UNITED STATES PATENT AND TRADEMARK OFFICE

APPLICATION NO.	FILING DATE	FIRST NAMED INVENTOR	ATTORNEY DOCKET NO.	CONFIRMATION NO.
09/887,337	06/25/2001	In Duk Song	8733.425.00	5925

Office Action Summary

DETAILED ACTION

FIG.5

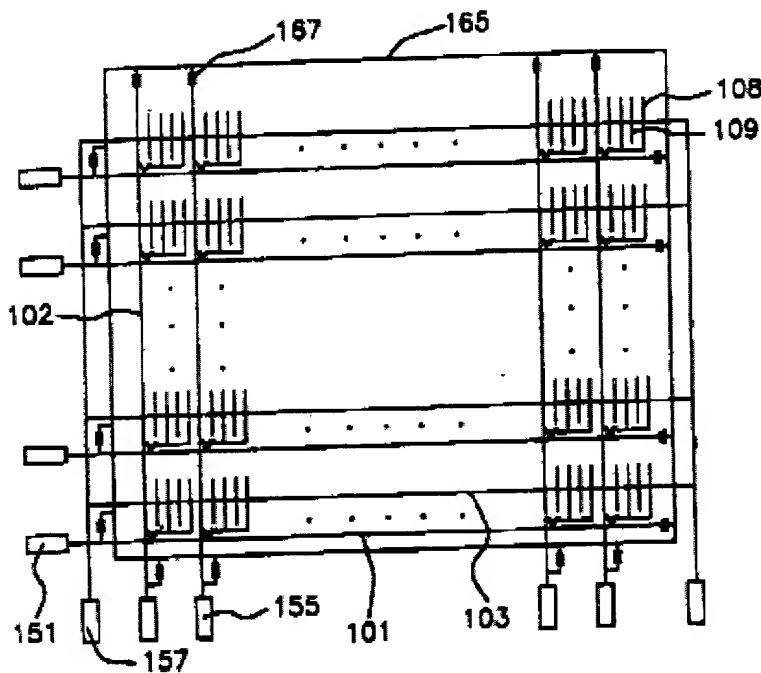
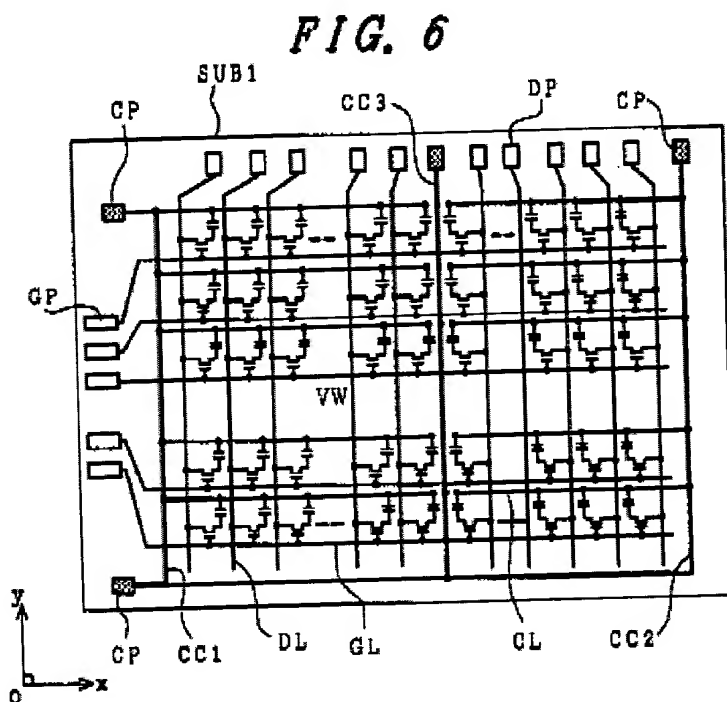
4. **Claims 1, 2 and 6-16 are rejected under 35 U.S.C. 102(e) as being anticipated by Komatsu, USPAT 6,335,770.**

5. Komatsu discloses in col. 5, lines 40-65 and shows in Fig. 5 (reproduced below), an in-plane switching type liquid crystal display device comprising:

- a plurality of data lines (102) for applying data signals to a thin film transistor array;

- a plurality of gate lines (101) for applying gate signals to the thin film transistor array;
- a plurality of gate links extended from the plurality of gate lines (101) into an outer area of the thin film transistor array; and
- a plurality of common voltage lines connected to common voltage pads (157), being provided in such a manner to cross the plurality of gate links, for applying a common voltage to the thin film transistor array.

Komatsu also shows in Fig. 5 that the common voltage lines are parallel to the gate lines (101).

Accordingly, claims 1, 2 and 6 are anticipated.

As to claim 7, Komatsu shows in Fig. 5 that the in-plane switching liquid crystal display device further comprising:

- a plurality of gate pads (151) connected to the gate links and electrically disposed between the gate links and an external power source; and
- a plurality of common voltage pads (157) connected to the common voltage lines and electrically disposed between the common voltage lines and the external power source.

Accordingly, claim 7 is anticipated.

As to claims 8-11 and 14, Fig. 5 of Komatsu also shows that the gate pads (151), data pads (155) and the common voltage pads (157) are located in an area outside of the thin film transistor array.

As to claims 12 and 13, Komatsu also shows in Fig. 5 that at least one common line that is parallel to the data line (102) crosses the gate lines (101) in an area between the gate pads (151) and the thin film transistor array.

As to claims 15 and 16, Komatsu shows in Fig. 5 that at least one common line crosses the data lines (102) in an area between the data pads (155) and the thin film transistor array.
